Work Order ID 150752

Item Name: Heli-Access-Step™ RH - Low Gear, Short Step, Aerazur Float Compatible

DART SERVICE INSTRUCTION

TO AMEND INSTALLATION INSTRUCTIONS D350-591 REV. G OR EARLIER
AND
INSTRUCTIONS OF CONTINUED AIRWORTHINESS ICA-D350-591 REV. 2 OR EARLIER
REF CANADIAN STC: SH92-6
REF FAA STC: SH967NE

FIGURE 1: CLAMP DETAIL
OPTIONAL CLAMP CONFIGURATION

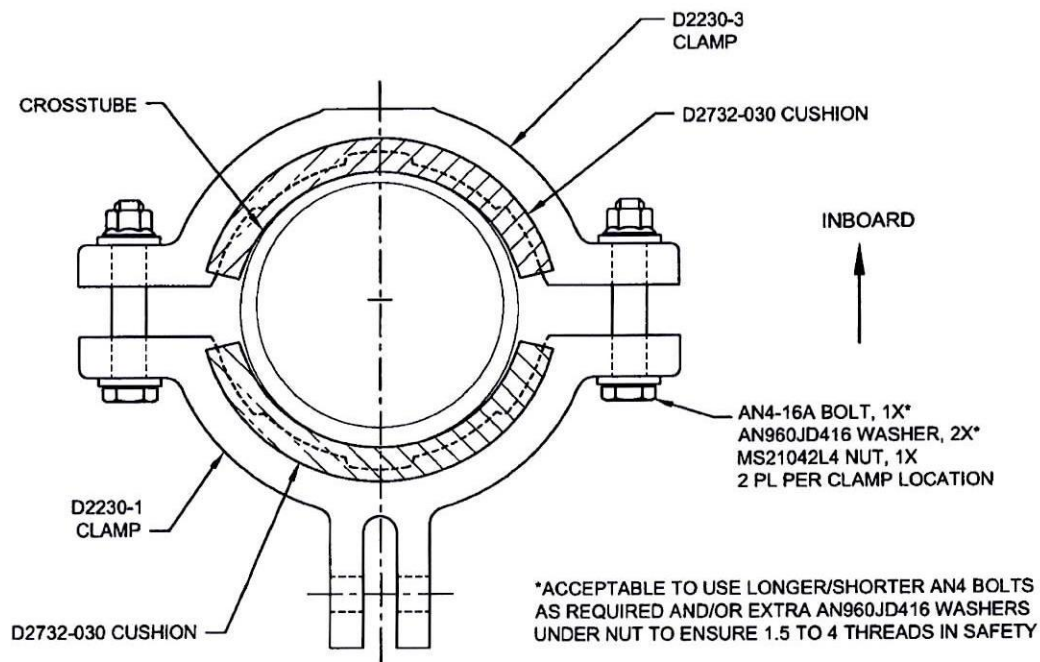
For D350-591-213/-214/-215/-216 steps, customers have the option of installing D2732-030 cushion under the clamps to accommodate varying crosstube diameters and to improve fit, as indicted in Installation Instructions D350-591. This Service Instruction adds longer AN4-16A bolts to the parts list to allow installation of these cushions. See Figure 1 on sheet 2 of this service instruction for reference. Installation of the D2856-400-720 Abrasion Strips per Installation Instructions D350-591 is not required when the cushions are installed.

For D350-591-213/-214/-215/-216 steps at CHG 003, the parts list of D350-591 Rev. G and ICA-D350-591 Rev. 2 is amended as follows:

ADD:

Qty -213	Qty -214	Qty -215	Qty -216	Part Number	Description
X				D350-591-213	Heli-Access-Step ™, Short Step – High Skid, LH
	X			D350-591-214	Heli-Access-Step ™, Short Step – High Skid, RH
		X		D350-591-215	Heli-Access-Step ™, Short Step – Low Skid, LH
			X	D350-591-216	Heli-Access-Step ™, Short Step – Low Skid, RH
4	4	4	4	AN4-16A	BOLT
